NOTICE OF DECISION

PROJECT: Croston Lane Short Plat APPLICATION: Short Plat: SP14-00003

DATE OF DECISION: April 29, 2015

REQUEST: Subdivide a 46,985 square foot (1.08 acre) parcel into four single family residential lots, each lot 8,710 SF in area. Proposal includes two (2) tracts: Tract A (stormwater tract) - 8,289 SF and Tract B (drainage/utility easement) - 780 SF. The south portion of the site includes a steep slope critical area (approximately 13,690 SF) with slopes greater than 40%. The applicant has provided supporting geotechnical information to reduce the steep slope buffer from 50 feet to 10 feet, plus a 15-foot building setback. The steep slopes would be protected with a Native Growth Protection Easement (NGPE) on the lots. The residential lots would be accessed off SE Croston Lane.

SHEET <u>11</u> OF <u>19</u>

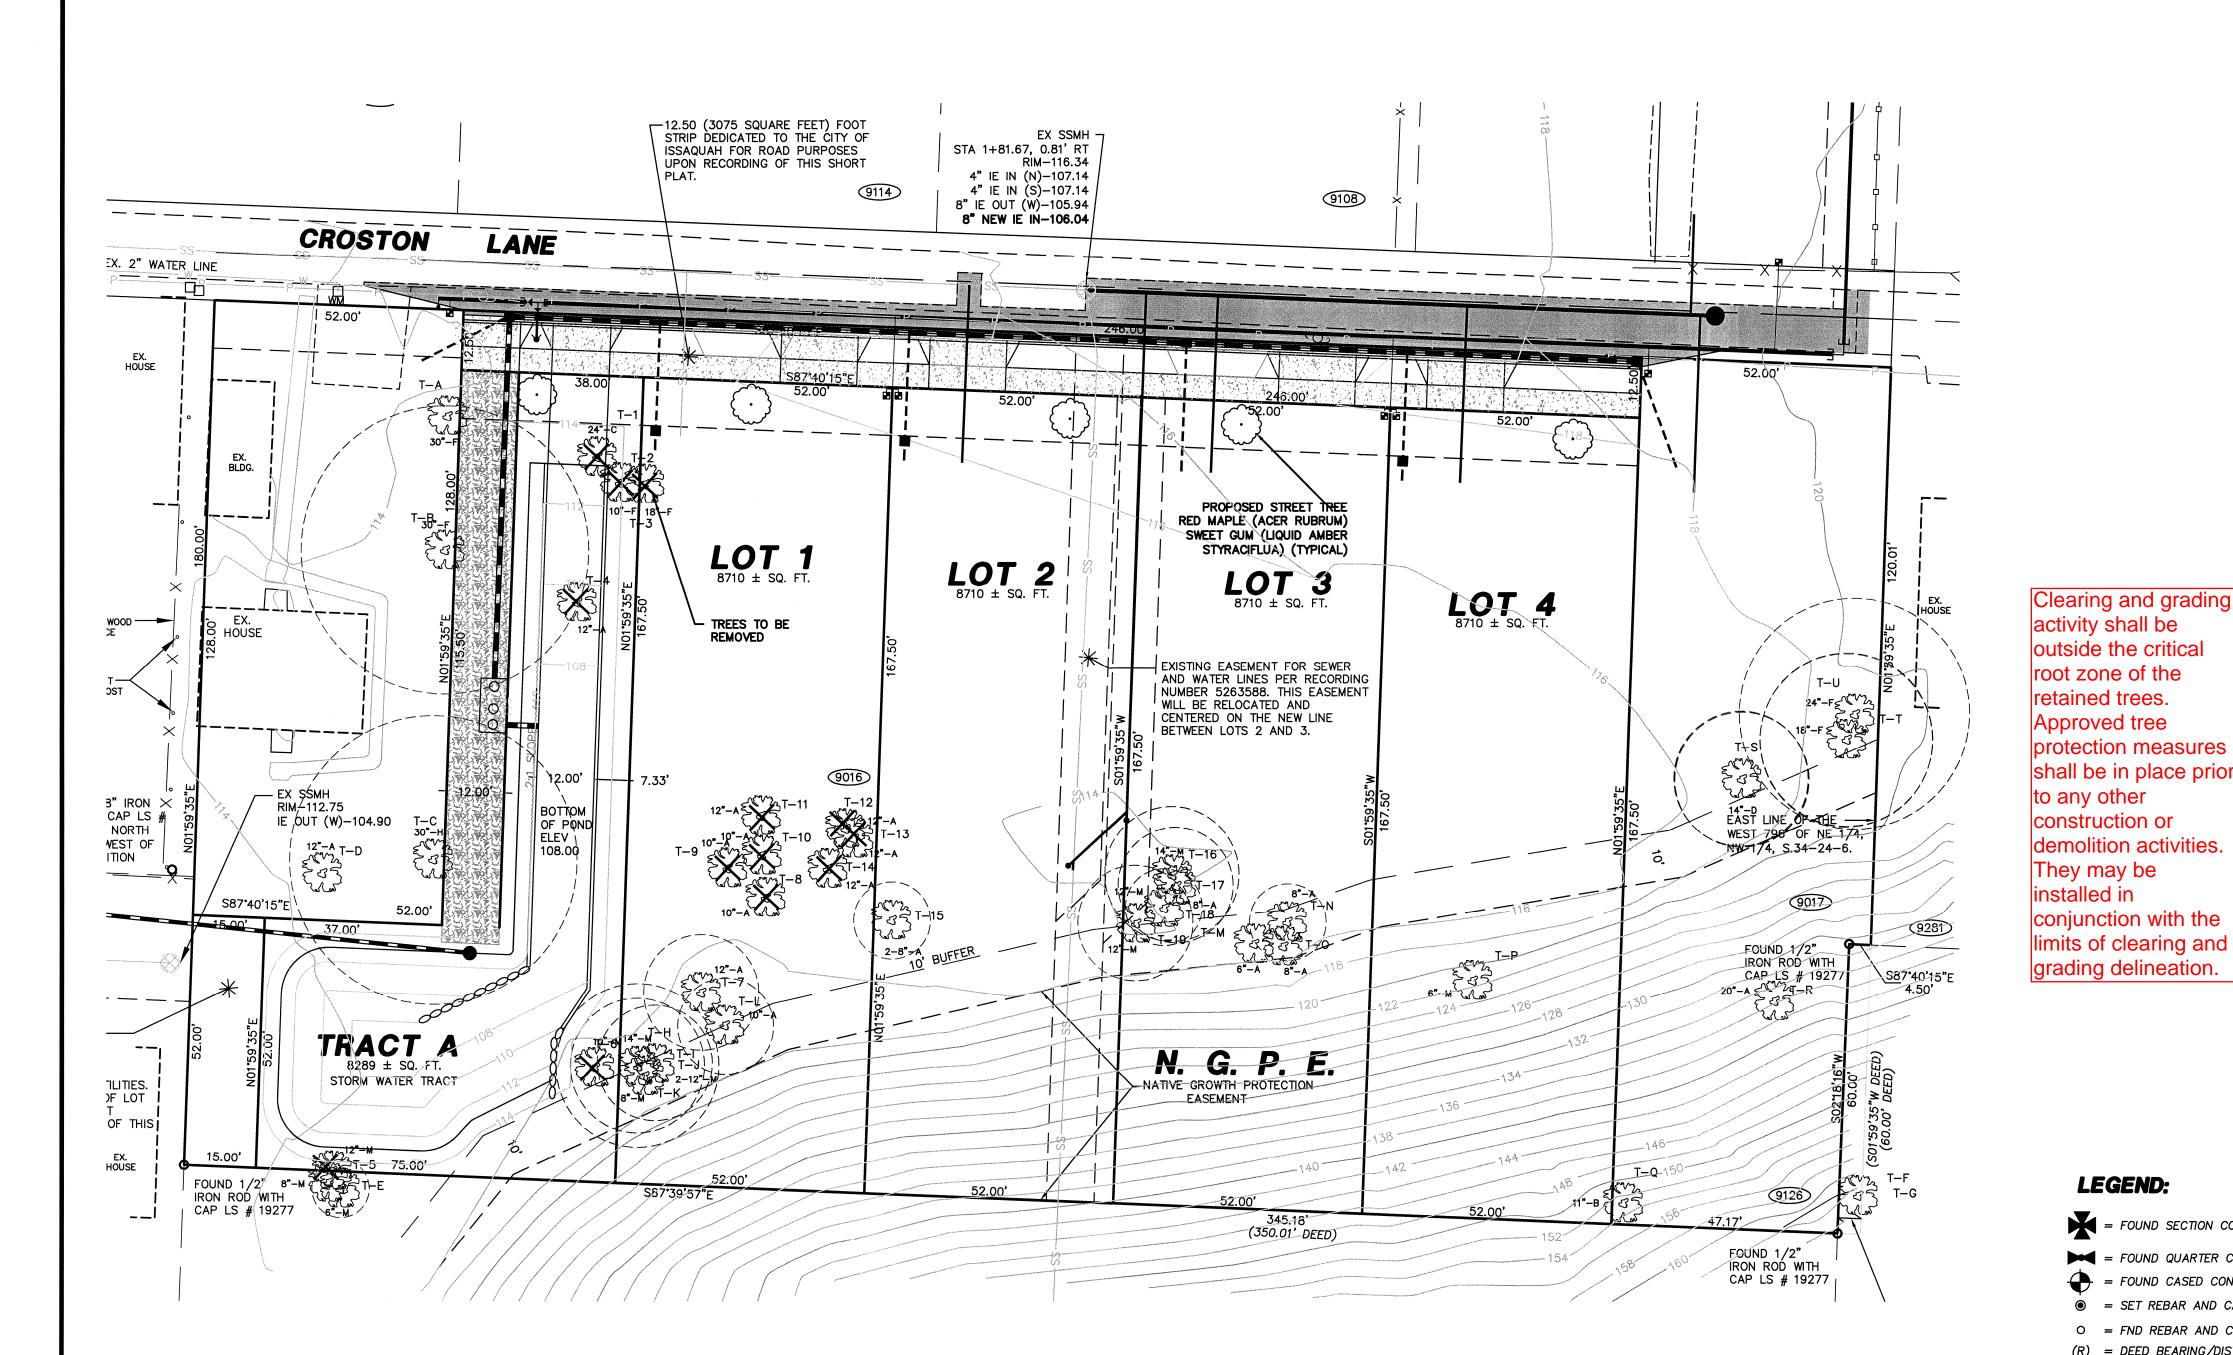
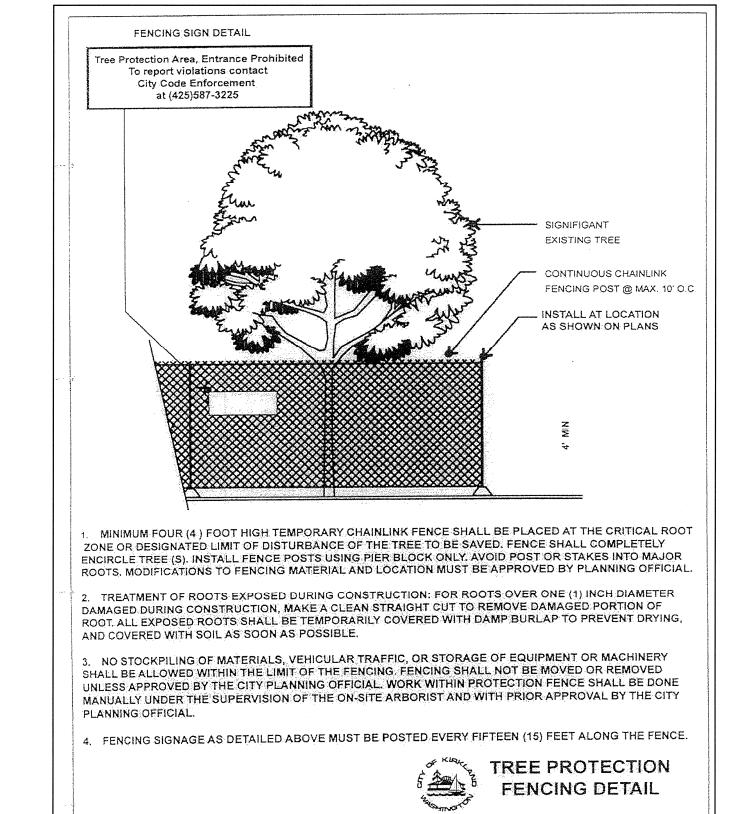
- 9. Tree Preservation: Retention of 30% of the total caliper of significant trees (6 inches caliper d.b.h. and greater) is required. The tree retention is required outside of critical areas and associated buffers. Sheet 4 (Tree Retention Plan) shows trees preserved in the steep slope area, which is required for steep slope areas but is not allowed toward the tree retention requirement. The applicant shall submit a revised Tree Retention Plan demonstrating retention of 30% of the total caliper of significant trees outside the steep slope critical area and buffer. The revised Tree Retention Plan shall be approved prior to issuance of
